PRODUCT CHANGE NOTICE

**Alternate Manufacturing Site
for Assembly of the Listed
Intersil SOT23 Packaged
Products**

**Refer to:
PCN10116**

Date: November 8, 2010

PCN100116 - Package Outline Drawing Updates

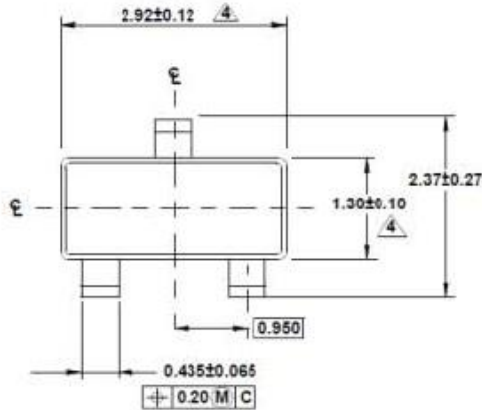
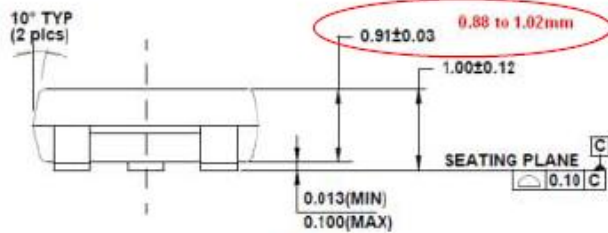
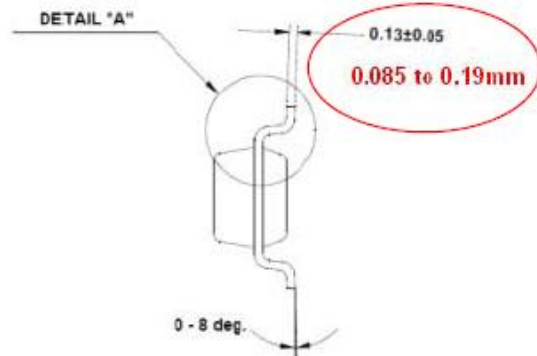
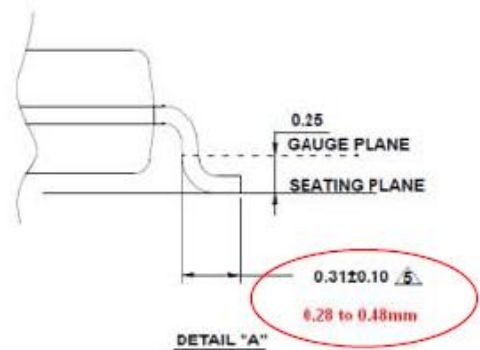
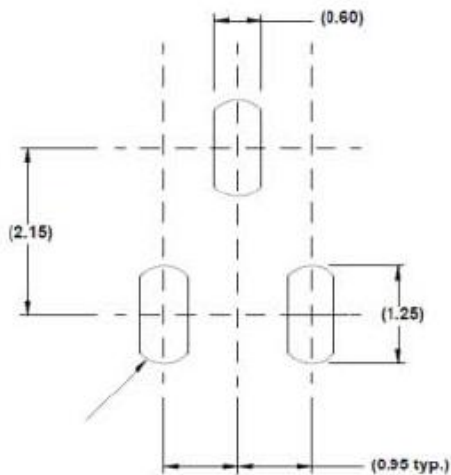
The Carsem (CAM) facilities are ISO 9001:2008 and ISO/TS 16949:2002 certified and currently qualified as a supplier to Intersil for assembly of SOT23 packaged products. The package outline drawing (POD) will require minor changes to three dimensions and is included for reference. There will be no change in the moisture sensitivity level (MSL). The same material set combinations are used at the current and CAM facilities.
